WEBER FIRE DISTRICT
Fire Marshall, Ted Black
Site Plan Review

SCALE: 1" = 20'		DATE: JULY 2011	DESIGN: TMN/SCC	DRAWN: SCC	CHECKED: TMN
REVISIONS	DESCRIPTION	DATE			
VINCE AND ALYSON FELT FELT SUBDIVISION STREET PLAN AND PROFILE WEBER COUNTY, UTAH					
 9875 South Adams Ave., Parkway, Suite 200 • Ogden, UT 84405 Phone (801) 776-0222 • Fax (801) 476-0286					
1		1

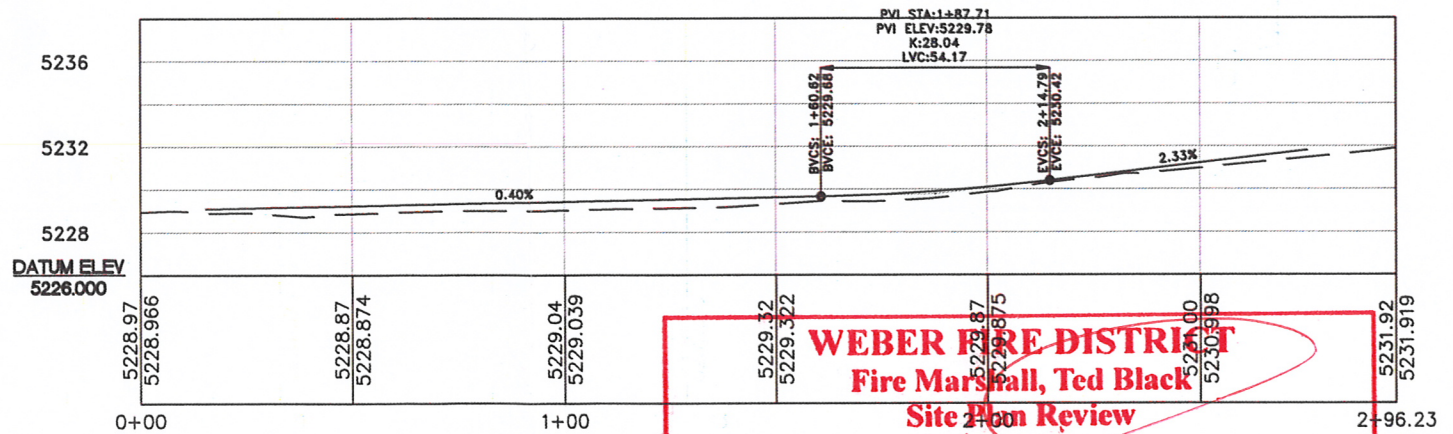
RELOCATE FIRE HYDRANT OR IE
8-23-11
